Project Title: Chick-fil-A at Gibson Building Permit #: _____ City Drainage #: _____

Re: **Chick-fil-A**
1600 Gibson Blvd. SE
Grading and Drainage Plan
Engineers Stamp Date 12/15/14 (M12-D015C)

Merrick & Company has reviewed the comments received on February 26, 2015 regarding the proposed Chick-fil-A located at 1600 Gibson Blvd. SE. The following summarizes Merrick's response to the comments provided by the City of Albuquerque.

1600 GIBSON BLVD.
SE
ALBUQUERQUE, NM

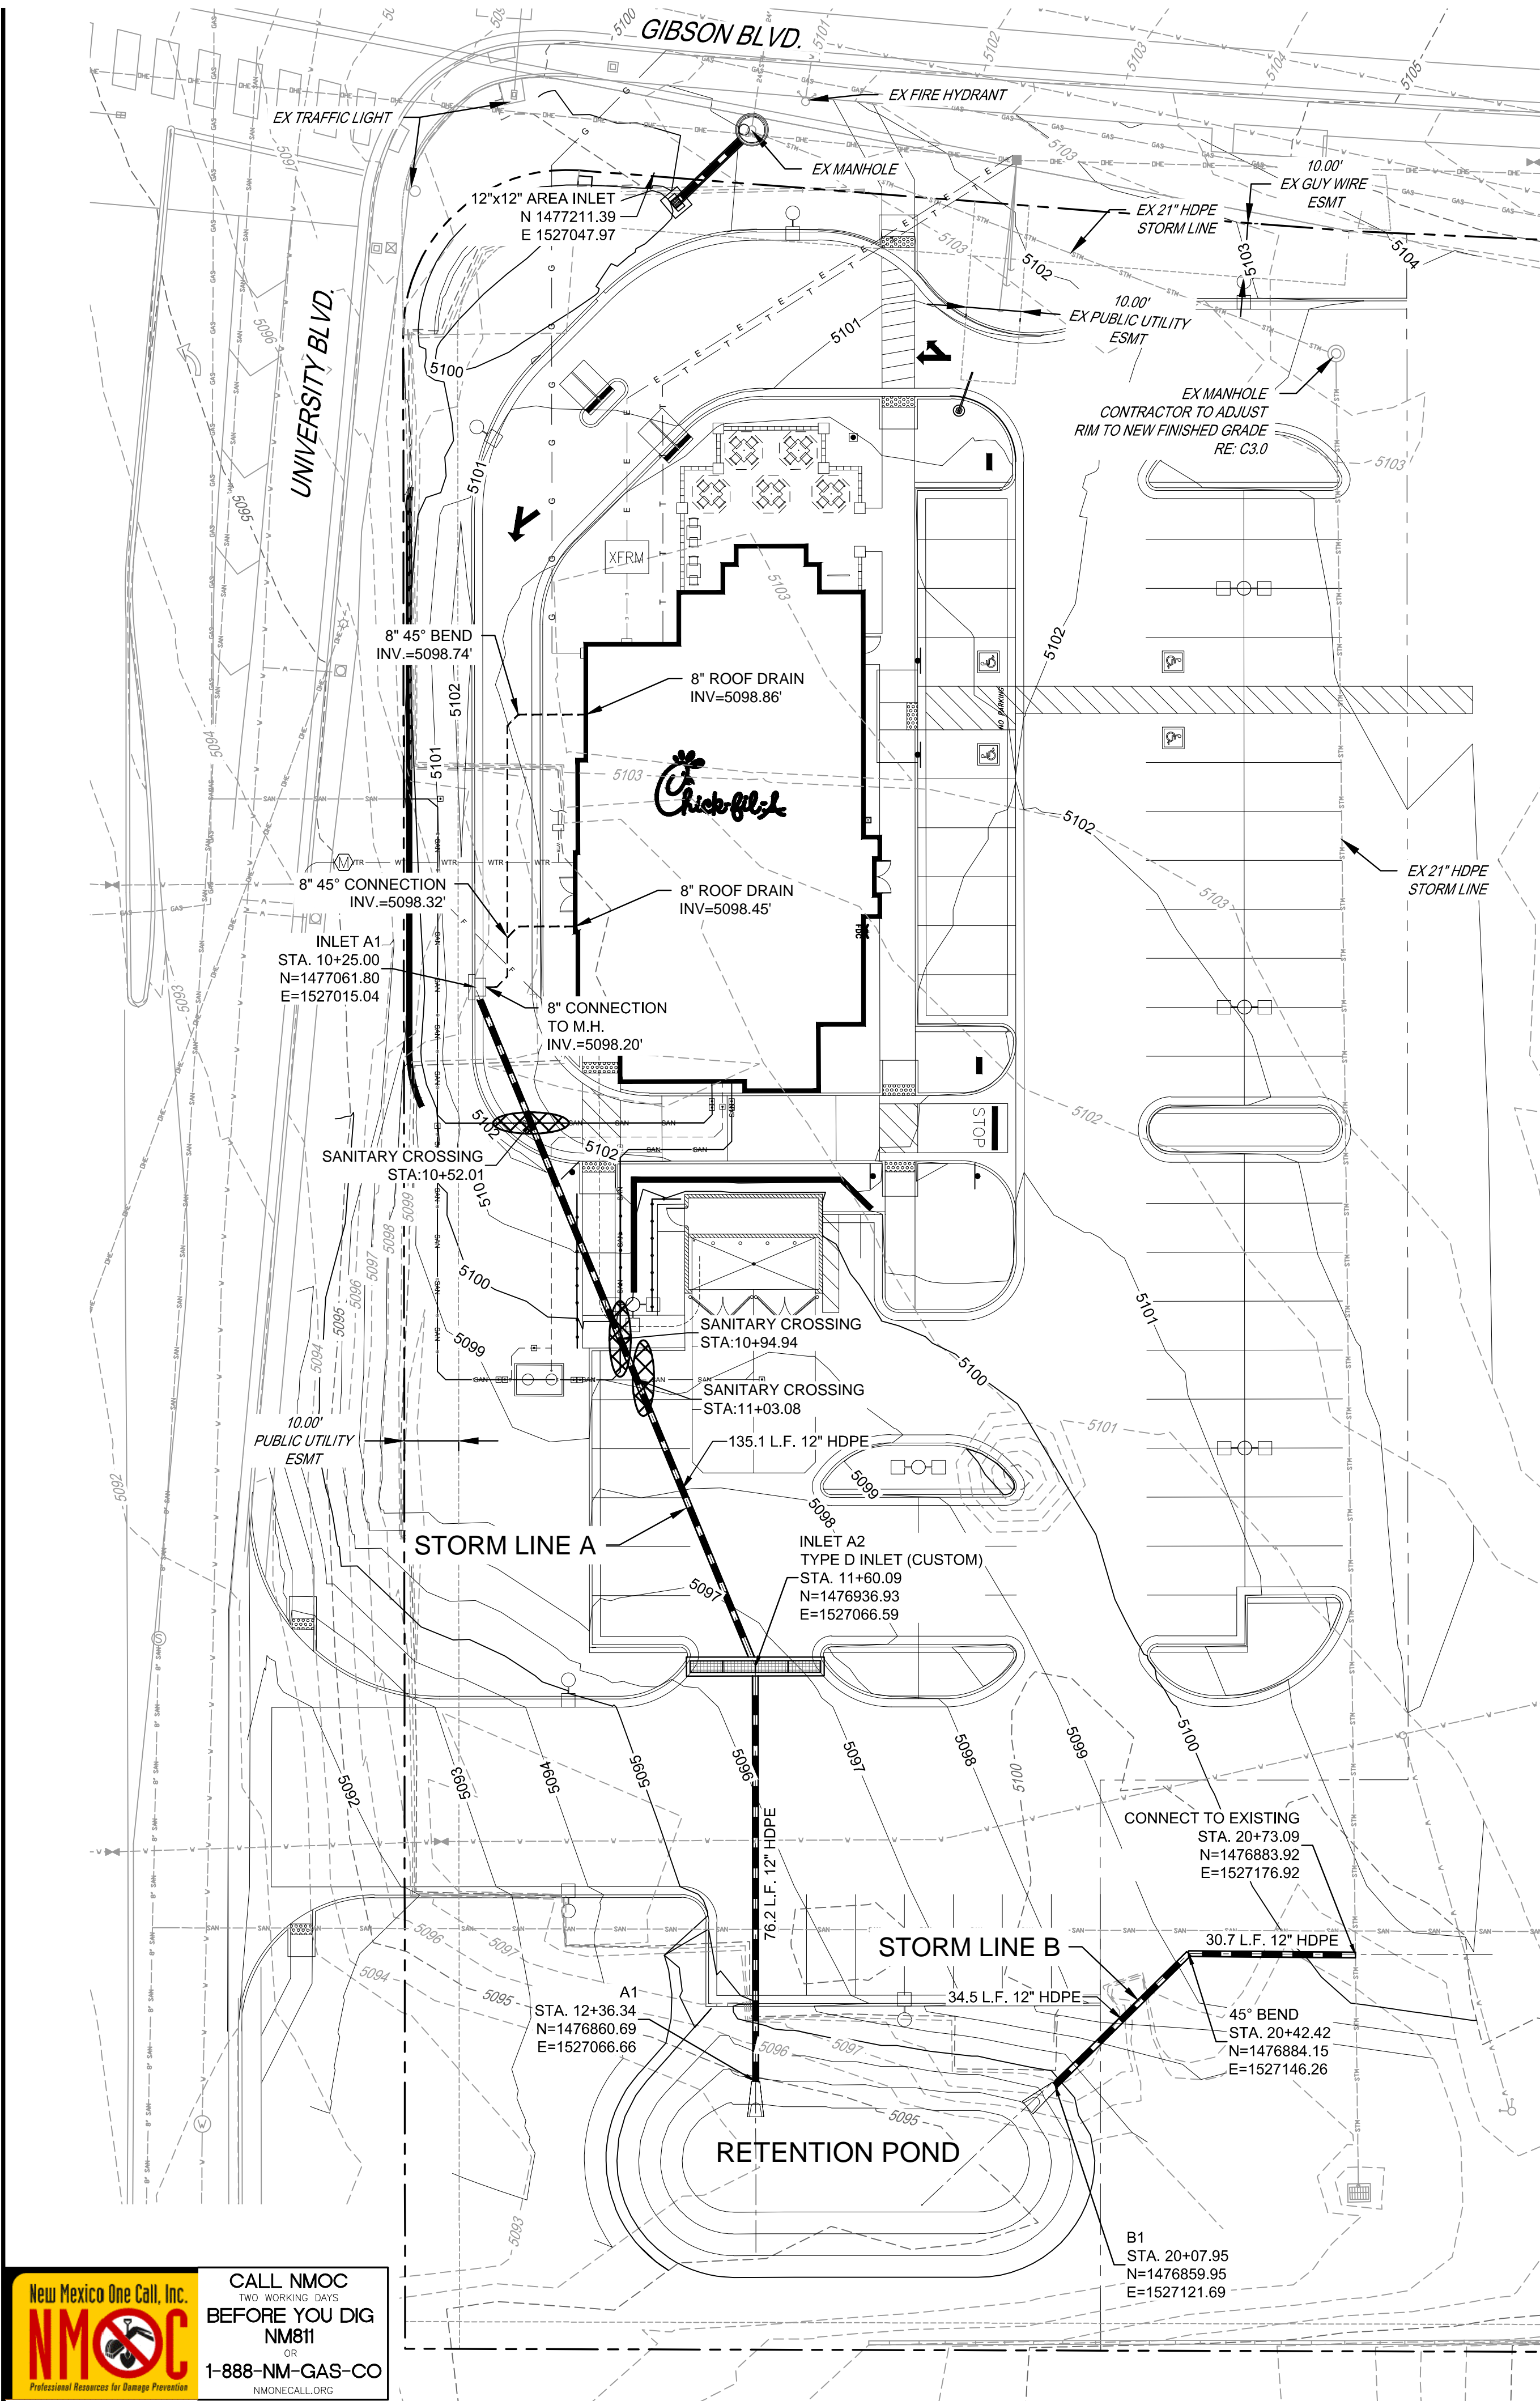
- Mention of the first flush per EPA standards is required. The amount required is .34" times the impervious area. We believe there is enough landscape area to accomplish this requirement.

- Provide the vicinity map for the area. Also provide the FIRMette or mention the flood zone and map page.

- Show the roof flows.

- Basin B-1 needs to flow through a first flush retention pond before leaving the site.

Response: The first flush has been mentioned in the drainage statement located on sheet C-3.2.

Response: Vicinity map and FIRMette have been added to the drainage pages.

Response: Roof flows have been added to the drainage map.

Response: A retention pond has been added to retain the first flush from basin B-1
